Access Compliance Report Public Rights-of-Way (Curb Ramps)

Main Street: TIGERTAIL_DR		Cross Street: MONTECITO_RD		Location:	W
ADA ID: RPRK211206150324	Ramp Type: Type 4 - Parallel	Initial Pass/Fail: Fail	Overall Compliance: No	Severity Score:	30
Codes/Mitigation Info/Possible Solution			Field Measurements/Component Compliance

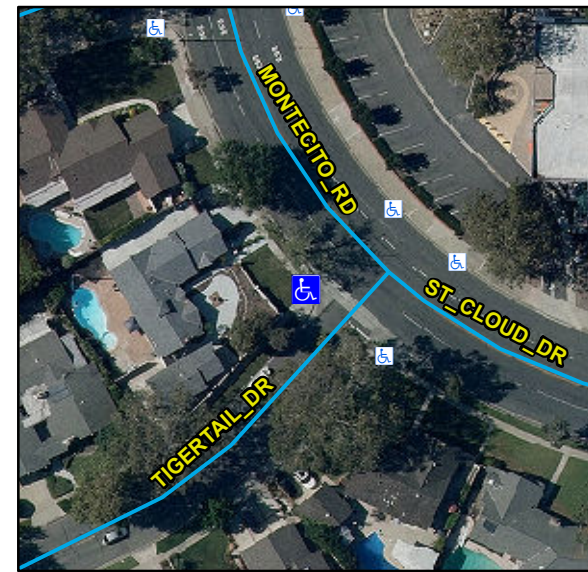
R304.3.2, R304.5.3, STD 1115

Compliance	Description	Data	Compliance	Description	Data
N/A	Ramp Length LT (in)	81	N/A	Ramp Length RT (in)	83
Yes	Ramp Width LT (in)	108	Yes	Ramp Width RT (in)	108
No	Ramp Run Slope LT (%)	8.9	Yes	Ramp Run Slope RT (%)	7.1
Yes	Ramp Cross Slope LT (%)	1.4	No	Ramp Cross Slope RT (%)	5.2
N/A	Landing Present	N/A	N/A	DWS Provided	N/A
N/A	Landing Length (in)	N/A	N/A	DWS Contrast	N/A
N/A	Landing Width (in)	N/A	N/A	DWS Length (in)	N/A
N/A	Landing Run Slope (%)	N/A	N/A	DWS Full Width	N/A
N/A	Landing Cross Slope (%)	N/A		DWS Offset Type	N/A
N/A	Landing Movement Obstructed?	N/A	N/A	DWS Offset Left (in)	N/A
	Landing Movement Type	N/A	N/A	DWS Offset Right (in)	N/A
N/A	Landing Shared	N/A			
N/A	Clear Space	Yes			
N/A	Clear Space To Crosswalk (in)	N/A			
N/A	Marked Crosswalk 1	No	N/A	Marked Crosswalk 2	No
	Crossing 1 Direction	SE		Crossing 2 Direction	NE
N/A	Marked Crosswalk 1 Width (in)	N/A		Marked Crosswalk 2 Width (in)	N/A

Remove & Replace Curb Ramp With Two New Directional Ramps or Equivalent.
